**PROJECT:** Chippewa County – City/County Building Renovation

**PROJECT NO.:** 10-007

### **ADDENDUM ONE**

A1-A105-01

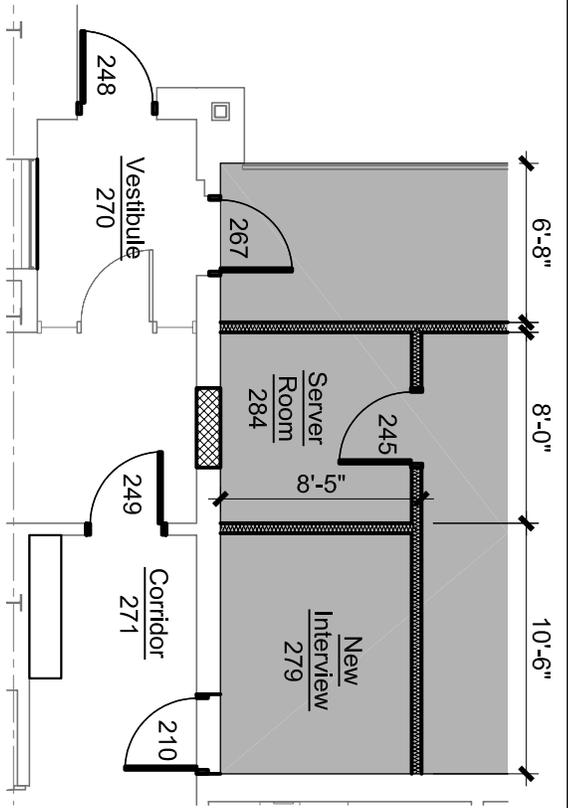
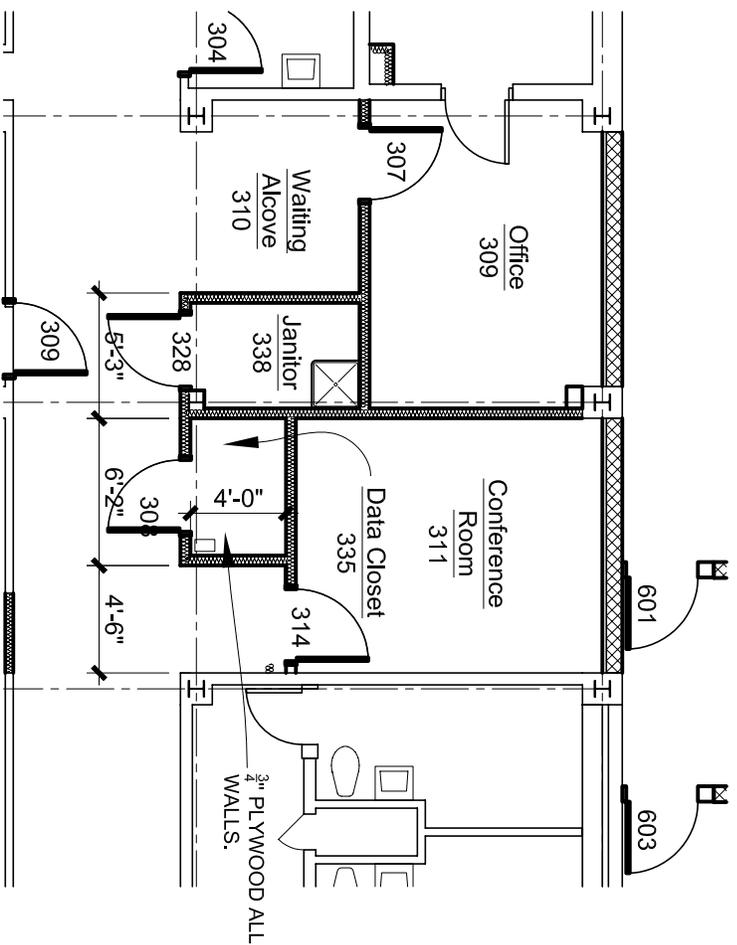
- b Revise Data Room 287 per attached Drawing A1-A105-01 (4'-0" wide)
  - c Add Server Room 284 and door 245 per attached Drawing A1-A105-01. Door 254 is:  
3'-0" x 7'-0" x 1 ¾" flush wood, in hollow metal frame with the following hardware:  
3 ea. hinges: TA2714 4 ½ x 4 ½ US26D - McKinney  
1 ea. Lockset: Storeroom Lockset: ML2057 – Corbin Russwin  
1 ea. Wall Stop: 400 US26D – Rockwood

- Server Room 284 Finishes:
- Floor: Carpet CPT-2
  - Base: Carpet CPTB
  - Walls: Paint P-1A
  - Ceiling: Acoustic Tile AC-2
